# Wisconsin Department of Transportation

**Proposal #40: 6600-00-72, WISC 2019 311  
Mosinee to Elderon  
Andrys Ln – CTH J (N)  
STH 153  
Marathon County**

This is Addendum No. 01, which provides for the following:

**ADDENDUM NO. 01**

Addendum No. 01  
 ID 6600-00-72  
 Revised Sheet 8  
 May 2, 2019

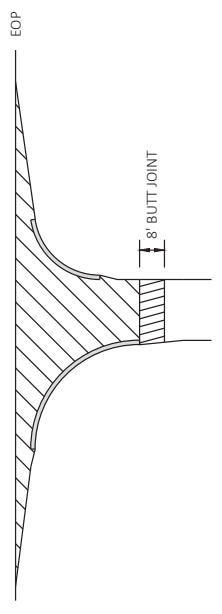
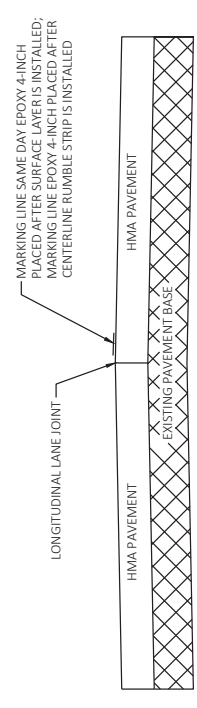
<b>Revised Plan Sheets</b>	
<b>Plan Sheet</b>	<b>Plan Sheet Title (brief description of changes to sheet)</b>
8	Modified side road detail to add Removing Asphaltic Surface Butt Joints concepts
31	Added table for Removing Asphaltic Surface Butt Joints
33	Modified HMA PWL Test Strip quantities

- REMOVING ASPHALTIC SURFACE MILLING
- REMOVING ASPHALTIC SURFACE BUTT JOINTS  
SEE BUTT JOINT DETAIL

- REMOVING ASPHALTIC SURFACE MILLING
- REMOVING ASPHALTIC SURFACE BUTT JOINTS  
SEE BUTT JOINT DETAIL
